# SERVICE INSTRUCTION

Service Instruction No. 1508  
Engineering Aspects are  
FAA Approved

SUBJECT: Magneto Attachment

MODELS AFFECTED: All Lycoming IO-360-A1B6D and IO-360-A3B6D engines installed in Mooney M20J-201 aircraft.

Figure 1.

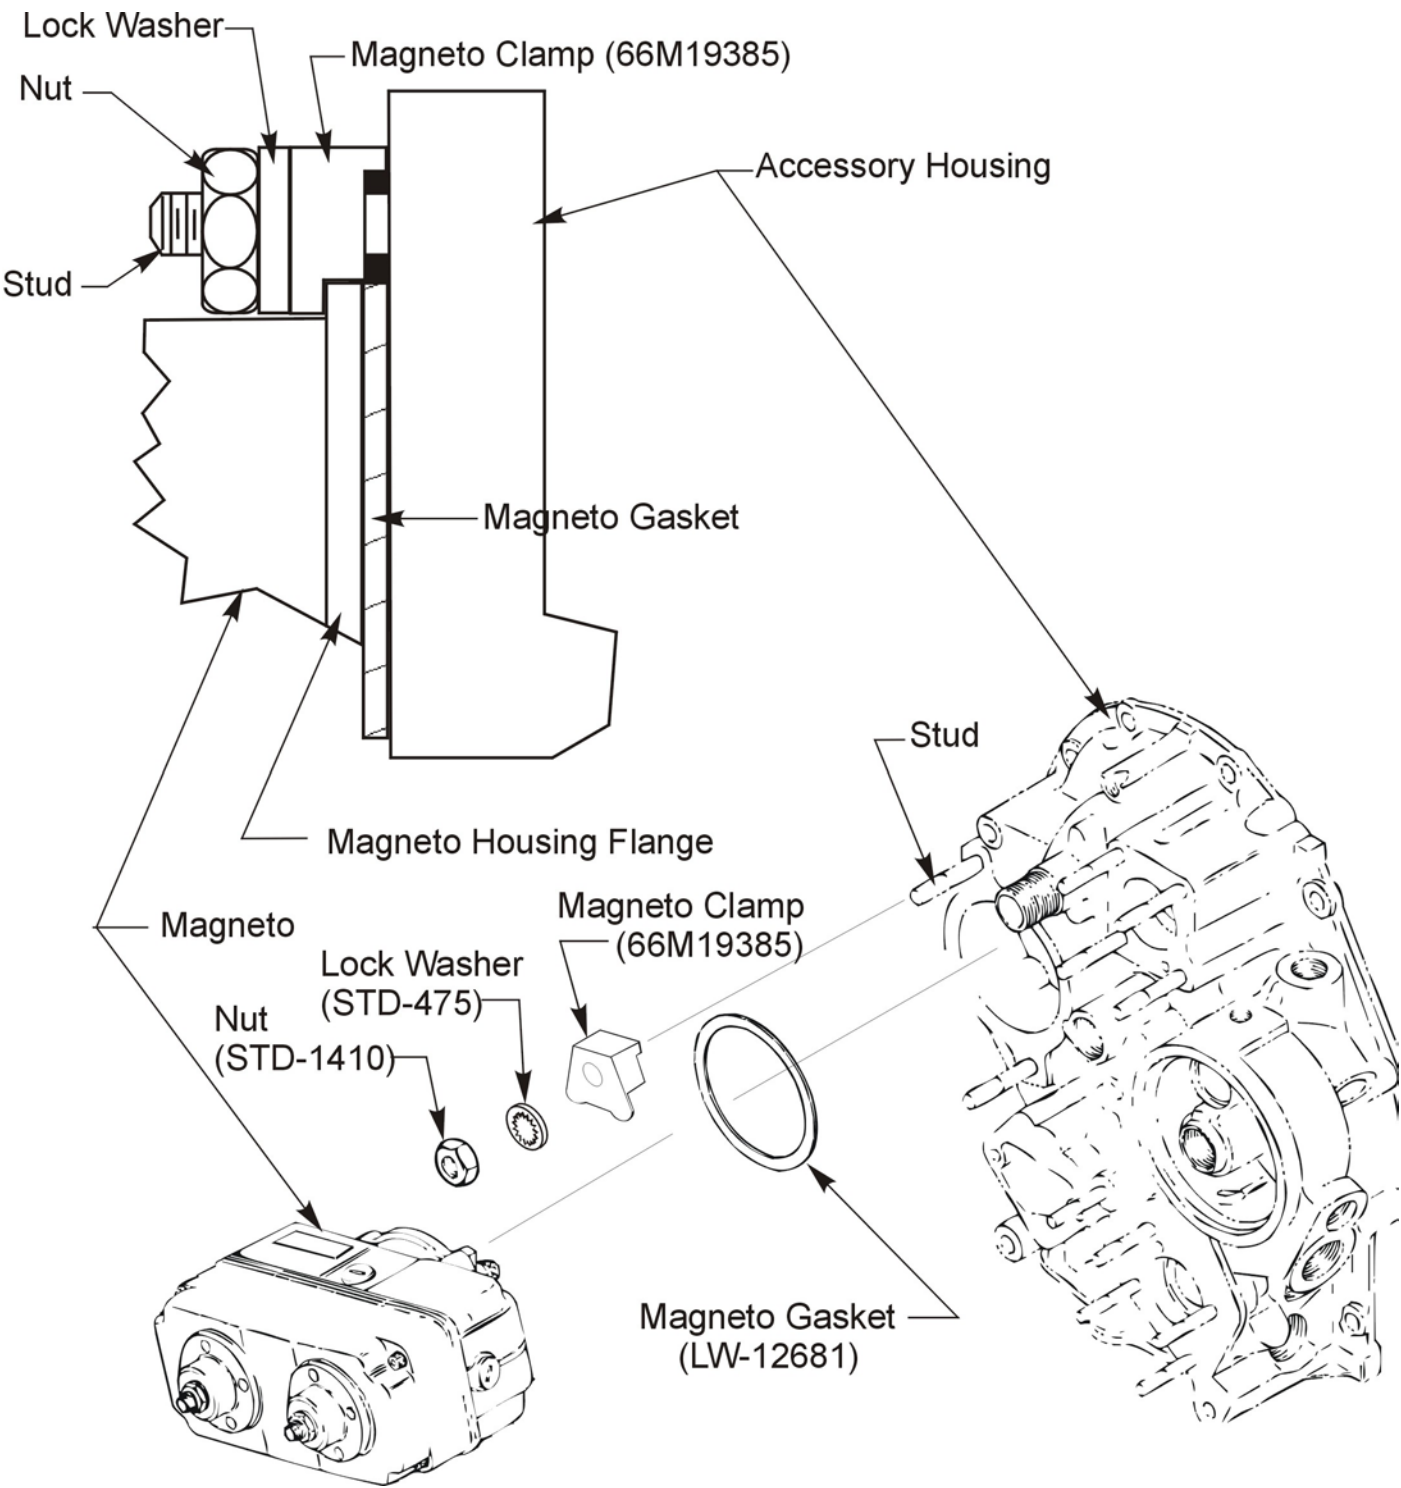
In the Mooney M20J-201 there have been reports of the hardware attaching the dual magneto to the studs in the engine accessory housing becoming loose after maintenance in the field. It is possible that during magneto maintenance, such as timing changes or checks, the attachment nuts are not being torqued to specifications or that hardware has not been installed properly.

At the next oil change interval, but not to exceed 50 hours of operation, and any time the magneto is serviced, the correct attachment of the magneto should be verified.

1. Inspect to be sure the correct gasket (P/N LW-12681) is being used. The gasket should be circular and no part of the gasket should extend beyond the flange of the magneto housing.
2. Be sure that the magneto clamps are P/N 66M19385 installed as shown. No other clamps are acceptable.
3. If an attaching nut is removed, install a new P/N STD-475 internal tooth 5/16 lockwasher as shown.
4. Be sure that the P/N STD-1410 attaching nuts are torqued to 17 ft.-lbs. (204 in.-lbs.).
